64TH St. & Oak Preliminary Drainage Report 3 engineering Job #: 5153 Original Date: April 10, 2020 COS #: 4-PA-2020

PRELIMINARY DRAINAGE REPORT

Stormwater Review by: **Ghassan Aouad** 480-312-7055 Phone: gaouad@scottsdaleaz.gov e-mail: Review Cycle 1 Date 05/22/2020

Drainage Maps (incl. Lower Indian Bend Wash FLO2D)

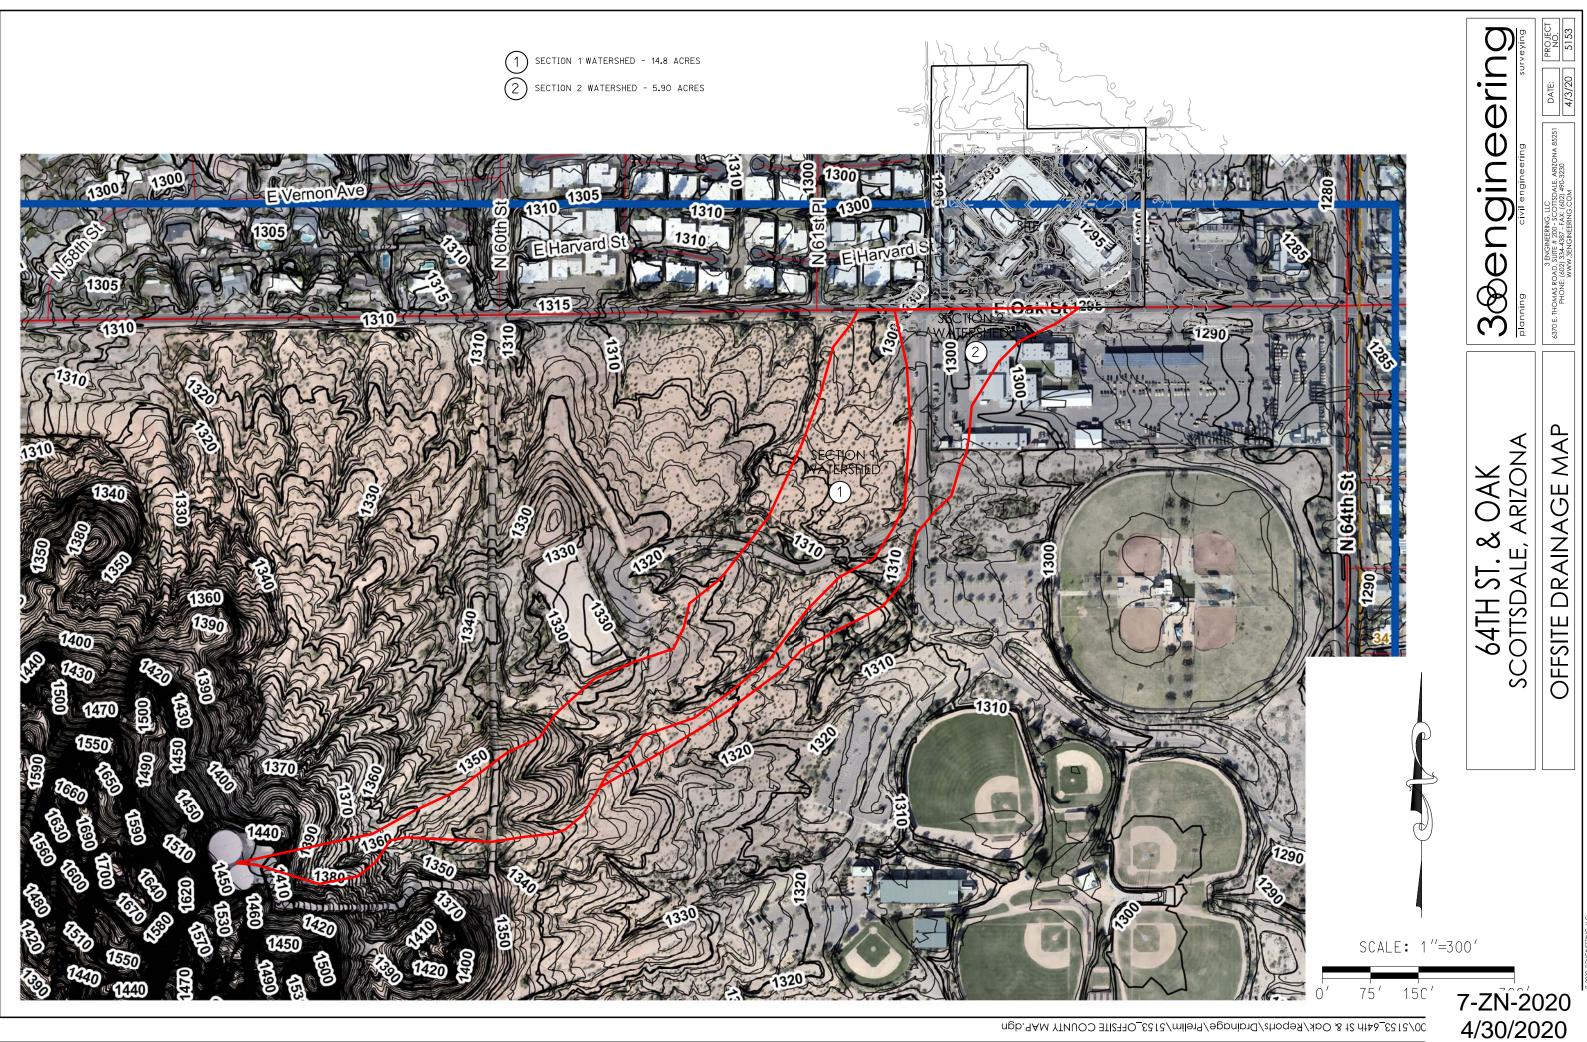
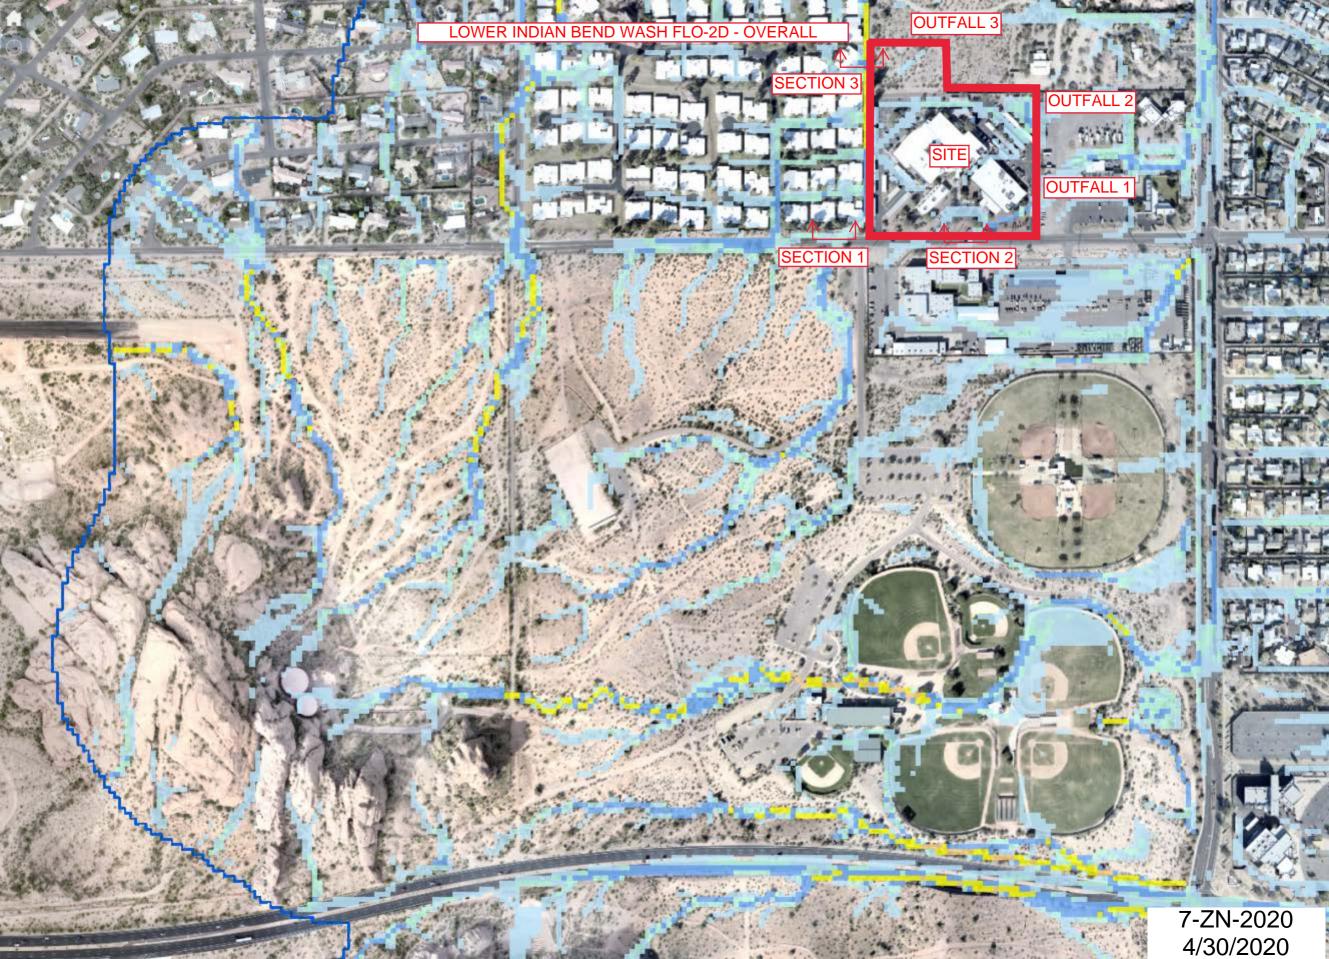
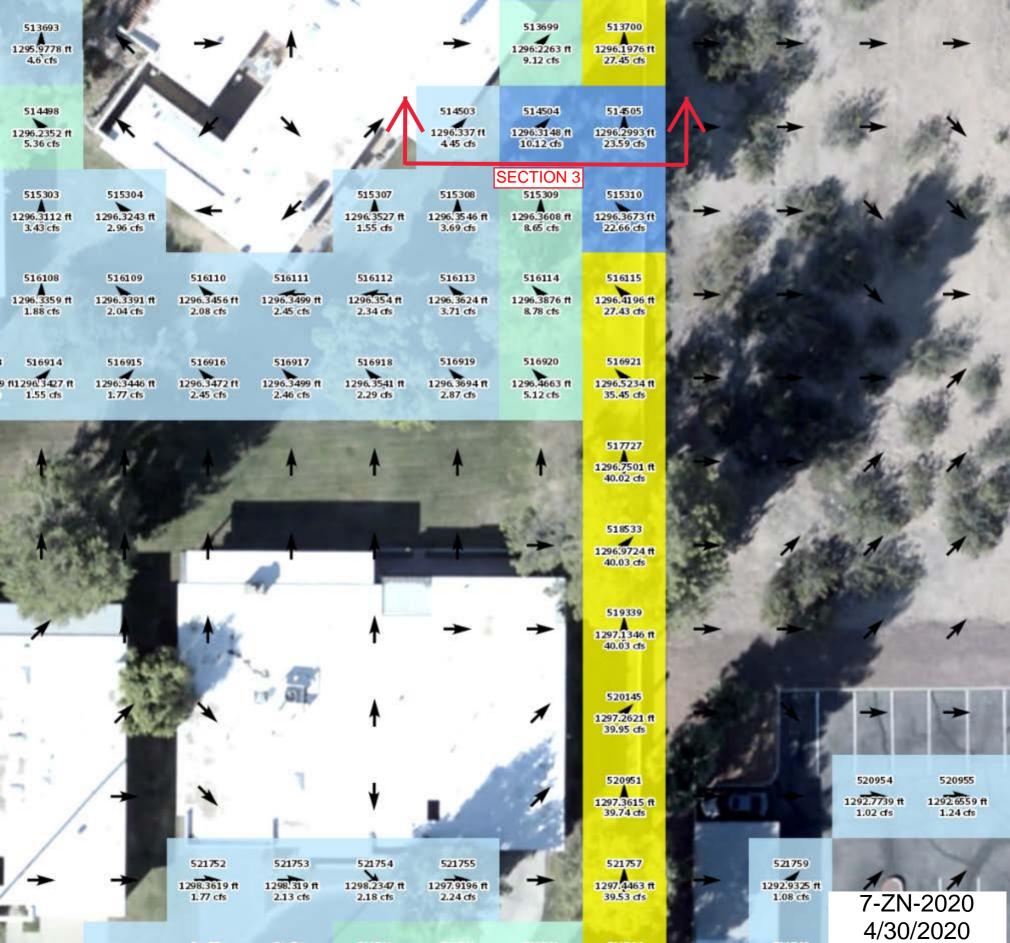
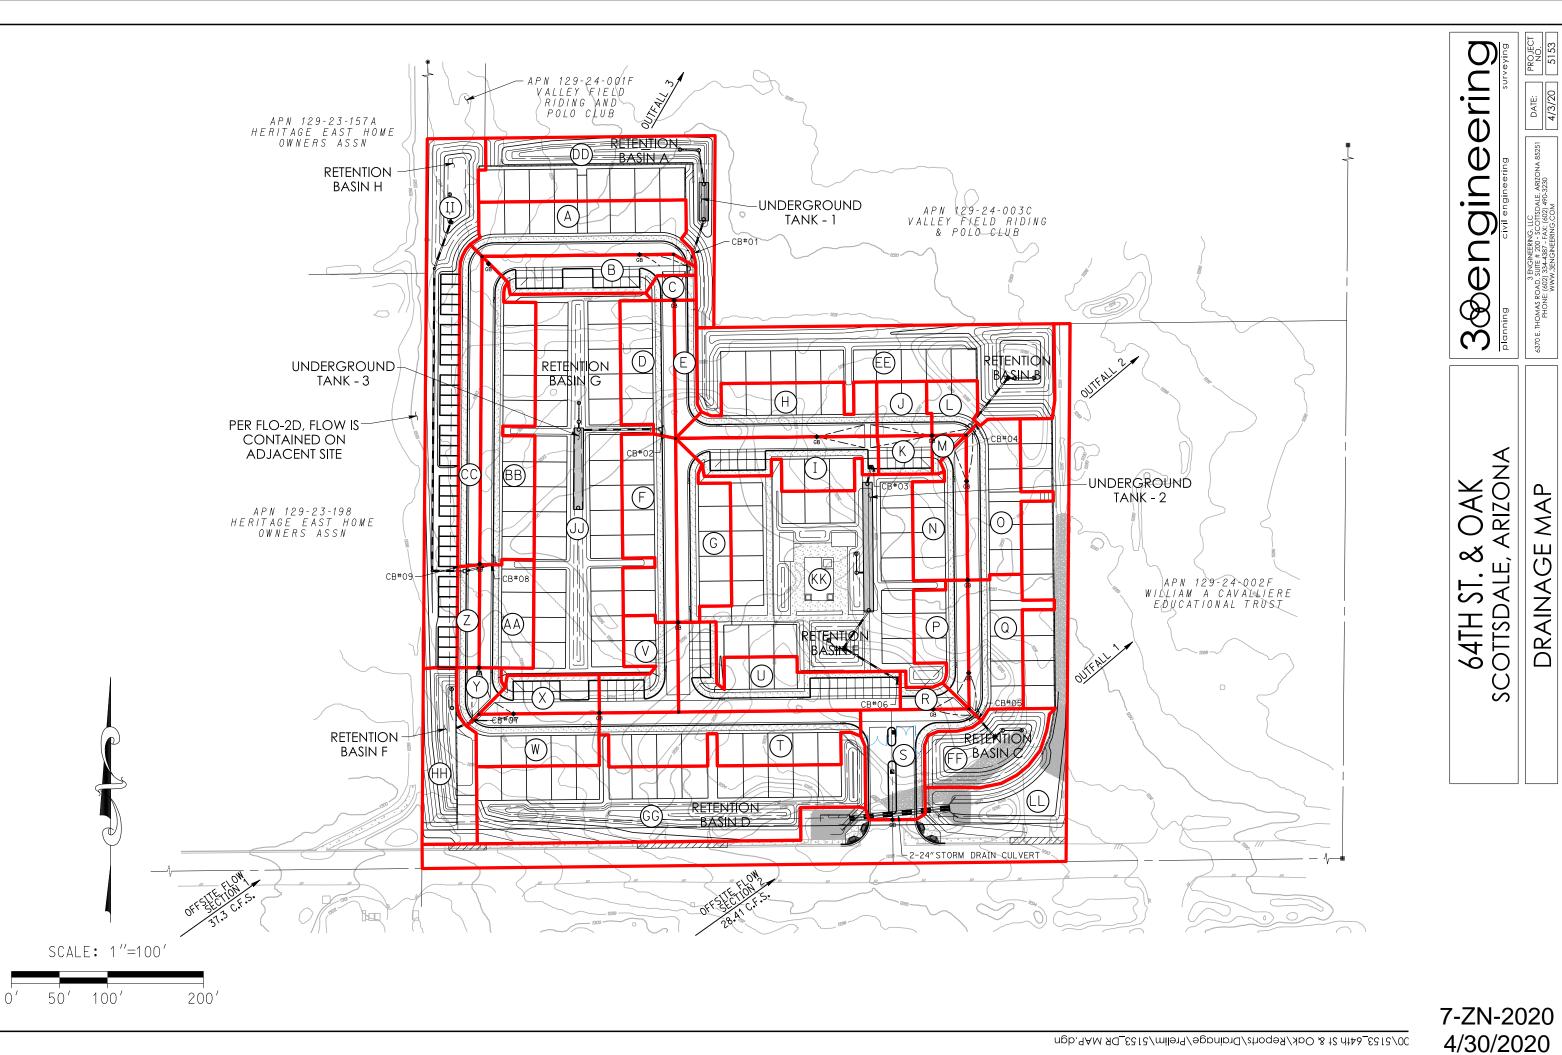
The existing topography may no agree with the FLO-2D output regarding the outfall along the riprap channel. The existing topography reflects a drainage channel that continues north toward the NE corner. It is good that the project is planning to maintain this channel. The existing channel pattern and capacity needs to be maintained.
